HISTORIC AND DESIGN REVIEW COMMISSION

April 03, 2024

HDRC CASE NO: 2024-133
ADDRESS: 523 E HUISACHE AVE
LEGAL DESCRIPTION: NCB 3090 BLK 6 LOT 25
ZONING: R-4, H
CITY COUNCIL DIST.: 1
DISTRICT: Monte Vista Historic District
APPLICANT: Jennifer Torres /TORRES JENNIFER L & VELASQUEZ JOSE L
OWNER: Jennifer Torres /TORRES JENNIFER L & VELASQUEZ JOSE L
TYPE OF WORK: Porch railing and column installation
APPLICATION RECEIVED: March 05, 2024
60-DAY REVIEW: May 4, 2024
CASE MANAGER: Claudia Espinosa

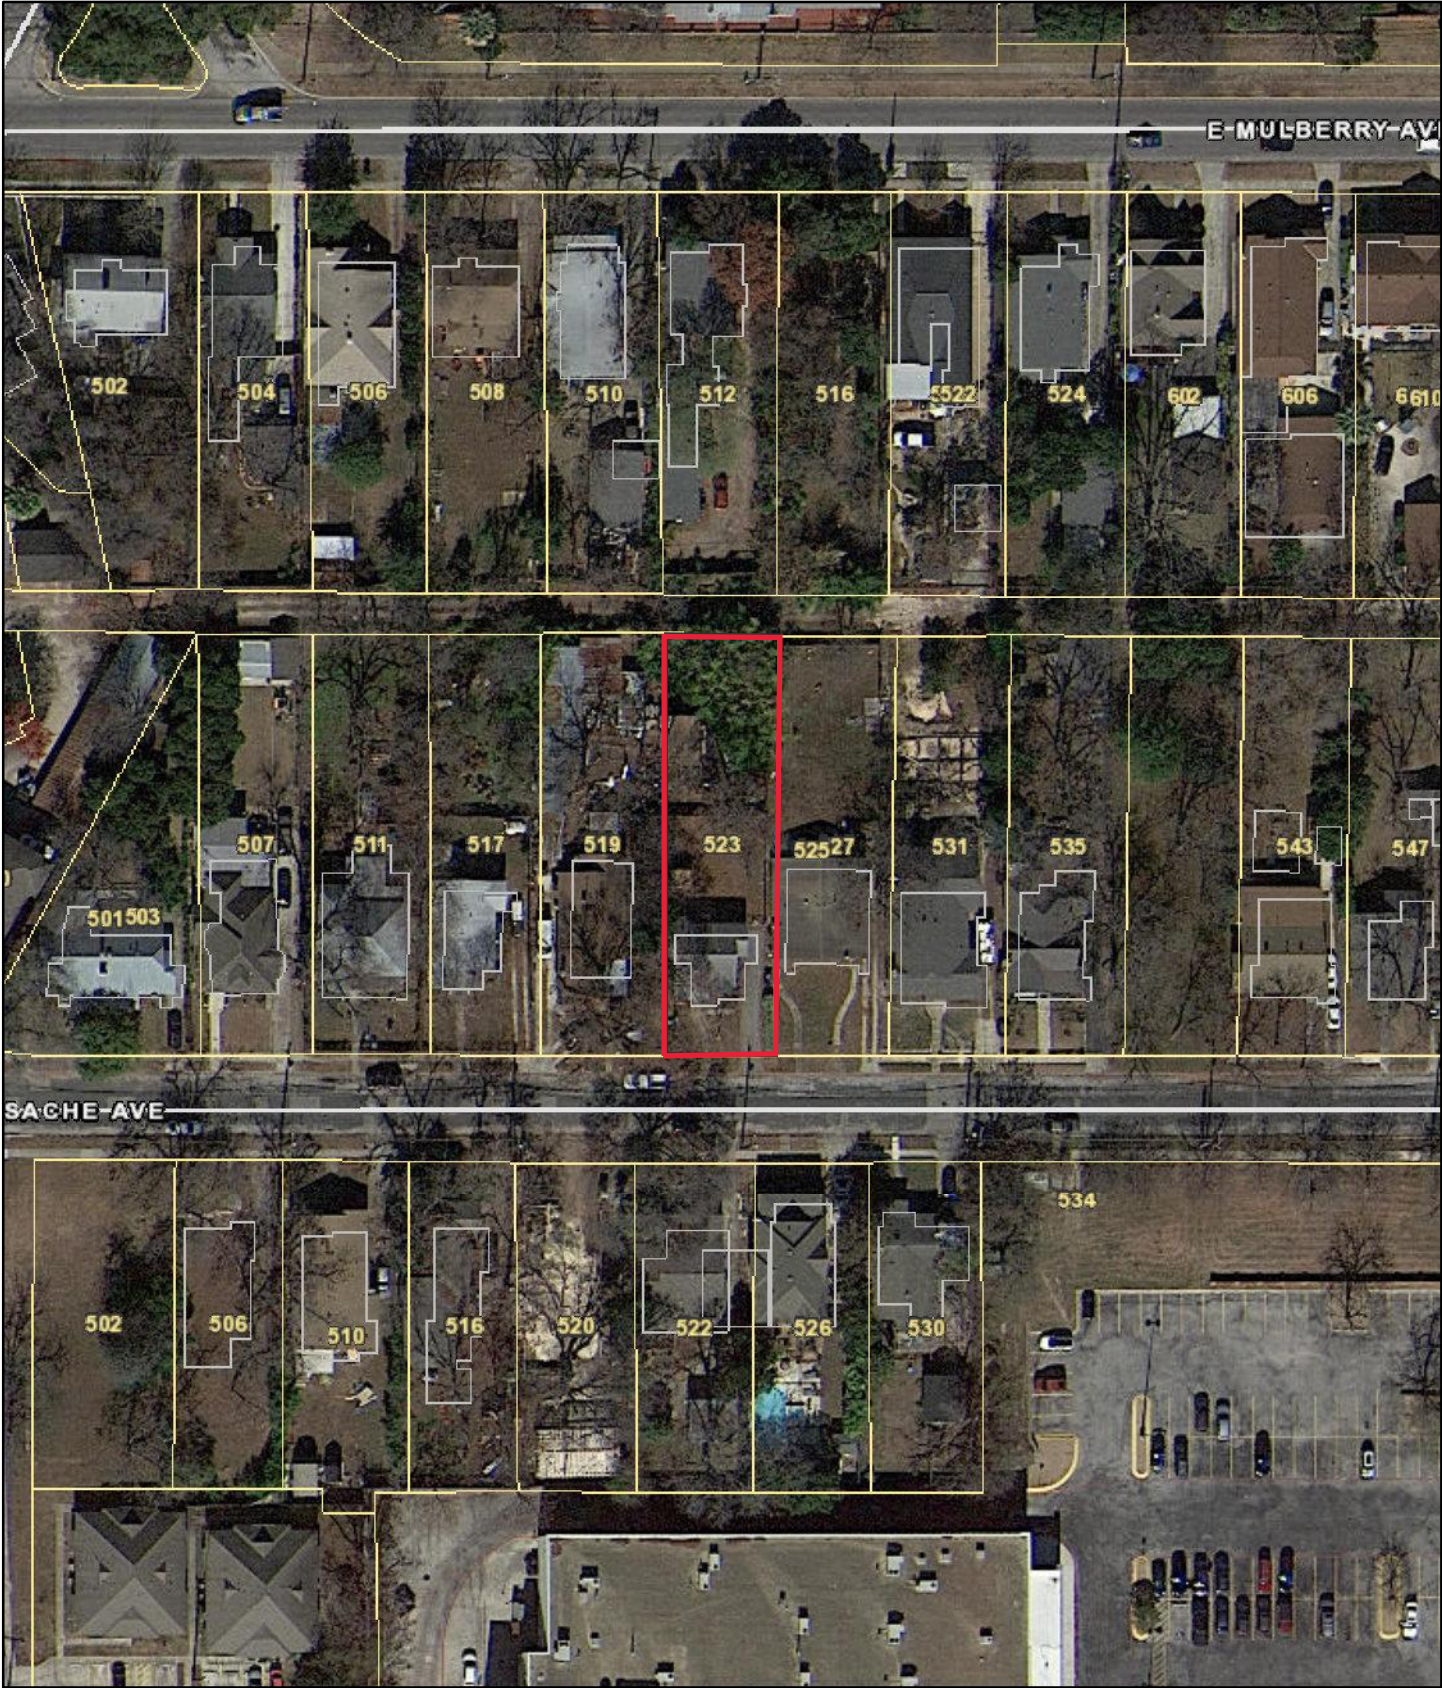
b. PORCH MODIFICATIONS (COLUMN INSTALLATION) – The applicant has proposed to install a wrought iron column to the center of the front porch. The Guidelines for Exterior Maintenance and Alterations 7.B.iv, state to design replacement elements, such as stairs, to be simple so as to not distract from the historic character of the building. Do not add new elements and details that create a false historic appearance. Staff finds that the installation of the column is simplistic in design and does not distract from the historical character of the structure and is consistent with the Guidelines.

c. PORCH RAILING – The applicant is requesting to install a four-foot tall wrought iron porch railing. The Porch Repair and Reconstruction Policy Guide states that new porch railings should feature both top and bottom rails, feature a simple design and be raised off of the deck surface. The proposed railings feature both a top and bottom rail. The bottom rail features a vertical orientation and will be installed approximately three to four inches above the porch decking. However, staff finds that the proposed railing should not feature an overall height of more than three (3) feet. Generally, this request is consistent with the Porch Repair and Reconstruction Policy Guide.

d. PORCH RAILING (GATE) – As part of the request for the porch railing, the applicant is request in enclose the porch railing with a gate located above the porch steps. The Guidelines for Exterior Maintenance and Alterations 7.B. iv, state to design replacement elements, such as stairs, to be simple so as to not distract from the historic character of the building. Do not add new elements and details that create a false historic appearance. Staff finds that that addition of the gate is simplistic in design and does not distract from the historical character of the structure. This request is generally consistent with the guidelines.

Item 1, staff recommends approval of the installation of a wrought iron porch column, based on finding b.

Item 2, staff recommends approval of the installation of wrought iron porch railing, based on finding c with the following stipulation:

- i. That the applicant submits updated renderings that reflect the height and dimensions of the proposed railing prior to the issuance of a Certificate of Appropriateness. The proposed railings should feature both a top and bottom rail. The bottom rail should feature a vertical orientation and should be installed approximately three to four inches above the porch decking. The proposed railing should not feature an overall height of more than three (3) feet.

Item 3, staff recommends approval of the installation of a wrought iron gate to the front porch railing based on finding d with the following stipulation:

- i. That the gate is installed in such a way that it can be fully removed from the porch railing.
